Department of Energy

Dear Mr. Linehan:

DOE-NRC MEETING
ON
THE GEOHYDROLOGY TESTING PROGRAM
FOR THE HANFORD SITE
BEFORE CONSTRUCTION OF THE EXPLORATORY SHAFT
Richland, Washington
April 7-9, 1987

RESPONSE TO LETTER FROM NRC STAFF
ABOUT THE GEOHYDROLOGY TESTING PROGRAM
AT HANFORD

LOCATION OF MULTIPLE-LEVEL PIEZOMETER FACILITIES

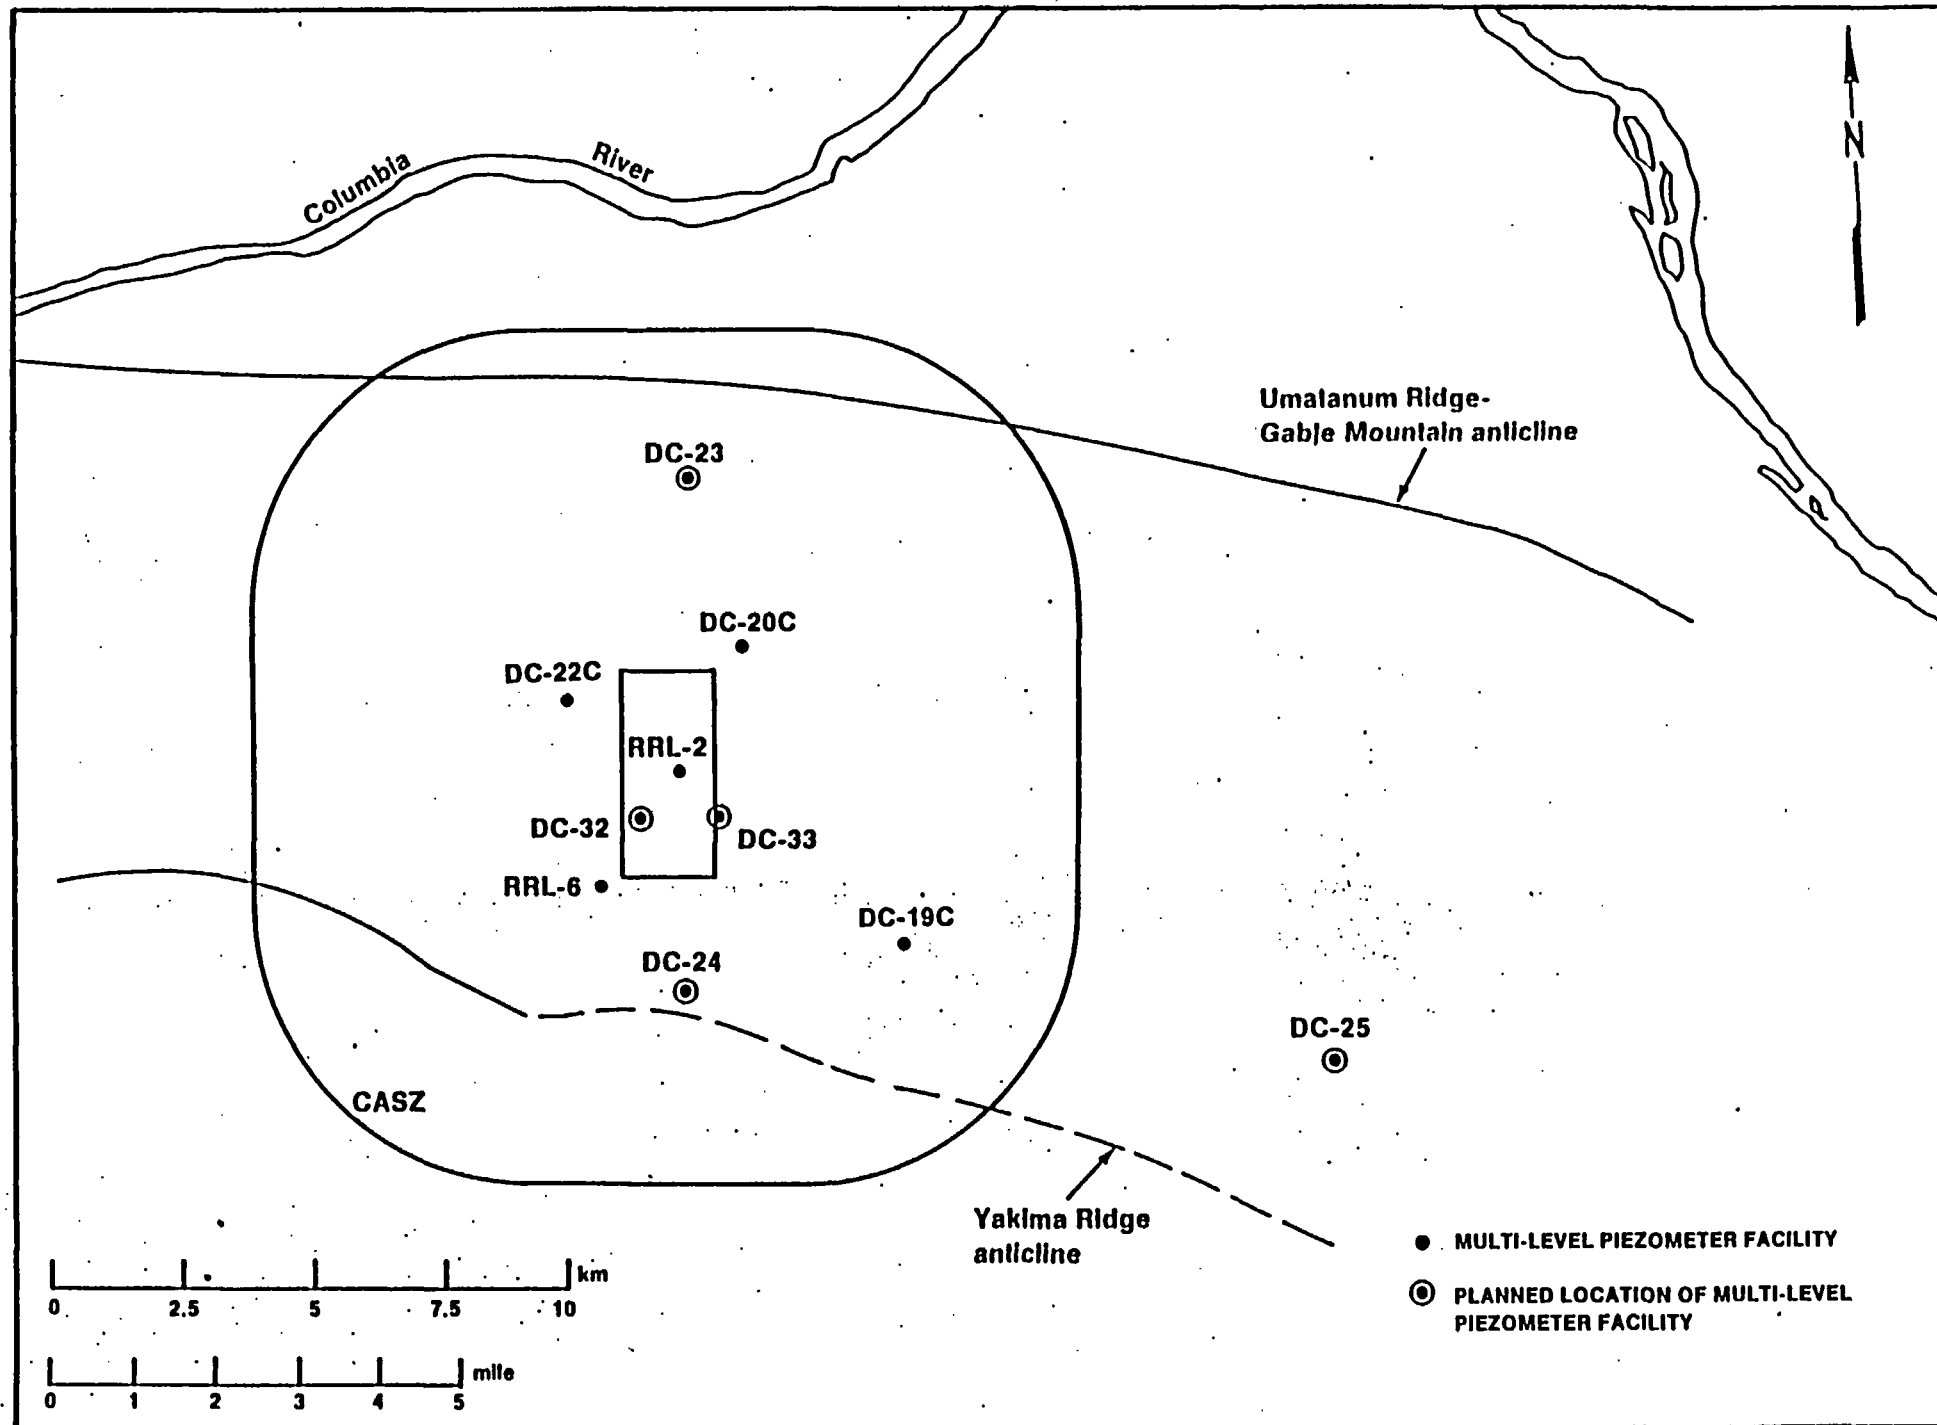
NRC Comment -

Current plans include the construction of additional multiple-level piezometer facilities at five sites; DC-23, DC-24, DC-25, DC-32, and DC-33 (figure 1) prior to initiating pre-ES LHS tests. At each site monitoring points will be provided in the Priest Rapids interflow, the Sentinel Gap flow top, the Ginkgo flow top, the Rocky Coulee flow top, the Cohassett flow top, the Birkett flow top, and the Umtanum flow top.
